PRODUCT/PROCESS CHANGE NOTICE (PCN)

PCN #: **TB1503-01 (R1)** DATE: **October 23, 2015**

This notification is to advise our customers that IDT has planned to standardize the carrier tape used to one type on selective package types.

Figure 1: Additional Label pasted on ESD/Moisture barrier bag and Pizza box

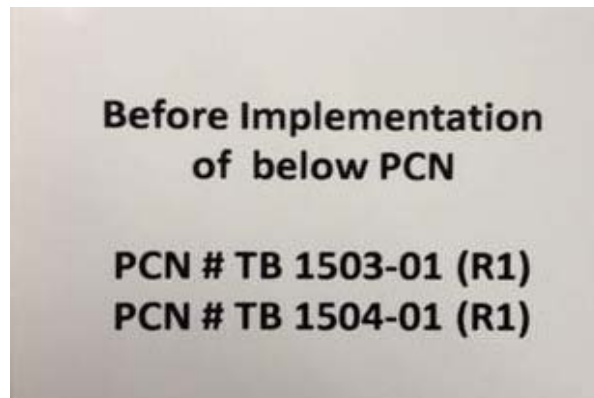
Customers may expect to receive shipments of products in new packing no sooner than 90 days from the date of this PCN notification. Shipments to customers may contain products shipped with either the existing packing or new packing during the transition period. Shipments made in the existing packing after the PCN becomes effective will have an additional label pasted on the ESD/moisture barrier bag and pizza box.

Illustration of Carrier Tape Pocket Design Change

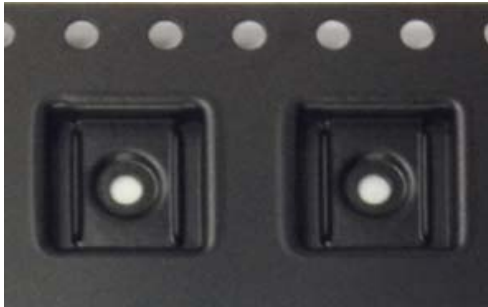
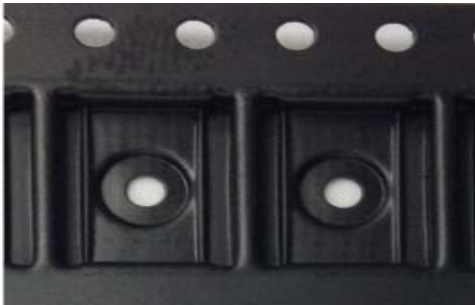
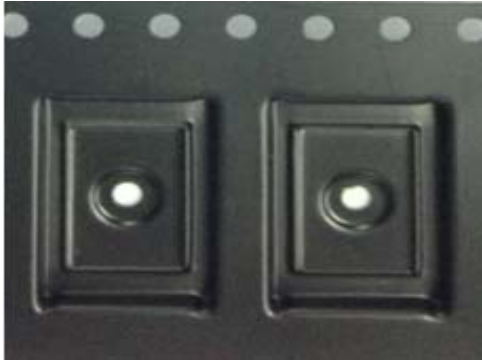
Package	From	To
TSSOP-20	Carrier Tape Part# P8-464-000 	Carrier Tape Part# P8-291-P20 
TSSOP-24	Carrier Tape Part# P8-329-P24 	Carrier Tape Part# P8-169-P24 
TSSOP-48	Carrier Tape Part# P8-260-P48 	Carrier Tape Part# P8-324-P48

Illustration of Carrier Tape Pocket Design Change

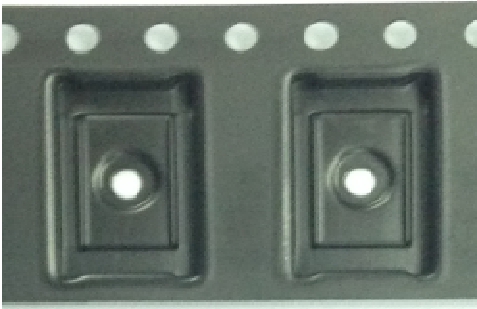
Package	From	To
SOIC-28	Carrier Tape Part# P8-187-S28 	Carrier Tape Part# P8-370-P28 
TSSOP-28 and TVSOP-48	Carrier Tape Part# P8-145-PF8 	Carrier Tape Part# P8-330-P48 
TSSOP-56	Carrier Tape Part# P8-261-P56 	Carrier Tape Part# P8-314-P56

Illustration of Carrier Tape Pocket Design Change

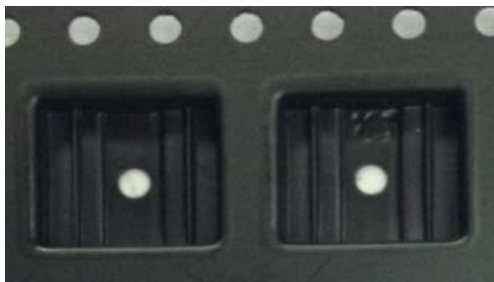
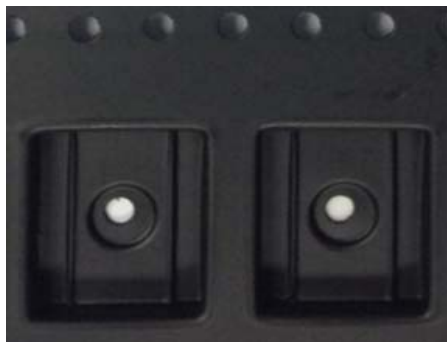
Package	From	To
SSOP-20	Carrier Tape Part# P8-259-P20 	Carrier Tape Part# P8-320-P20 
SSOP-28	Carrier Tape Part# P8-384-P28 	Carrier Tape Part# P8-321-P28
